REF: ASA VER SFRS

On behalf of ASA Properties, I am pleased to submit an application to amend the Veramendi Development & Design Control Document (DDCD).

3. Include a new Figure 21-2:

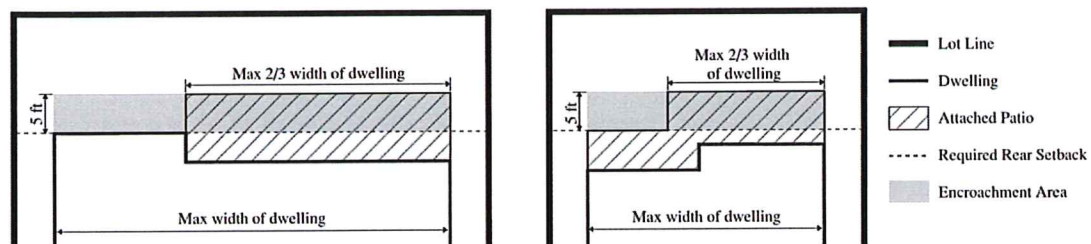
Encroachment Area: In relation to a single family dwelling, a rectangular area extending 5 feet into the required rear setback with a width equal to the widest part of dwelling where an Attached Patio may be located, as illustrated in Figure 21-2.

Patio, Attached: A private open space that is roofed, or unroofed with a code required hand rail, that is attached to a single family dwelling, excluding balconies. Unattached, roofed patios shall follow Accessory Structure standards.

Attached Patios may encroach into the required rear setback a maximum of 5 feet, provided the width of the Attached Patio within the Encroachment Area does not exceed two-thirds the maximum width of the single family dwelling. Portions of an Attached Patio located outside the Encroachment Area are not subject to the two-thirds maximum width restriction.
